**VIRGINIA ELECTRIC AND POWER COMPANY (DOMINION)**  
**SURRY POWER STATION UNIT 2**  
**CYCLE 19 CORE OPERATING LIMITS REPORT**

**CORE OPERATING LIMITS REPORT**  
**Surry 2 Cycle 19 Pattern AM**  
**Revision 0**

**Dominion Topical Report**  
**VEP-FRD-42 - Rev. 2.1-A**  
**Reload Nuclear Design Methodology**

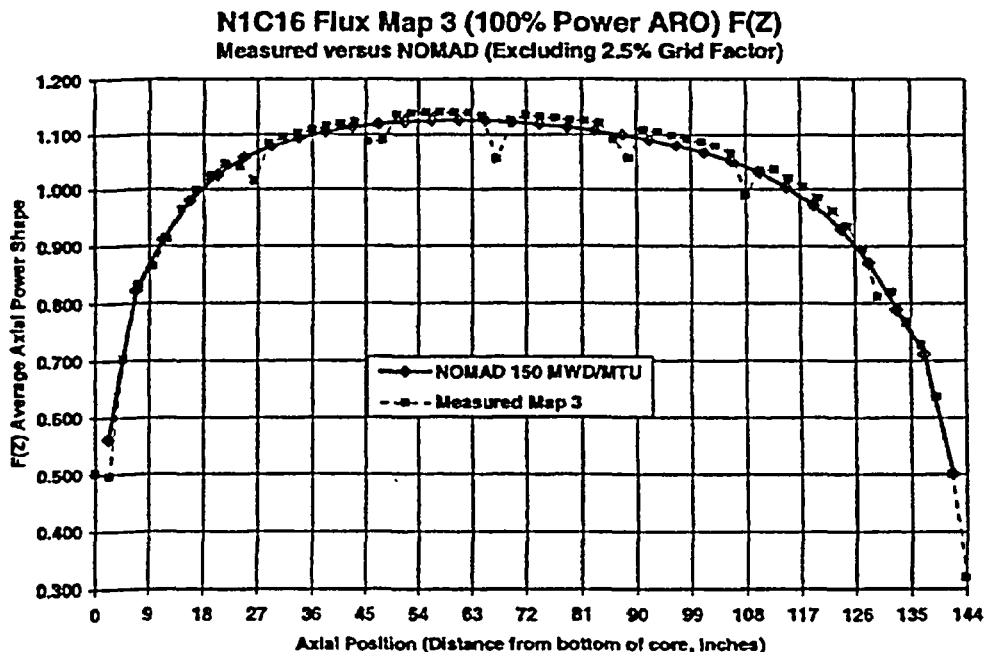
**NRC NOMAD QUESTION 1**

By letter dated December 2, 2002, VEPCO stated that the accuracy of the NOMAD model is verified each cycle during startup physics testing and during routine core follow. Please provide representative results from a recent refueling outage (comparisons between the startup physics test data and the NOMAD predictions) that demonstrate the accuracy of this model.

**DOMINION RESPONSE TO QUESTION 1**
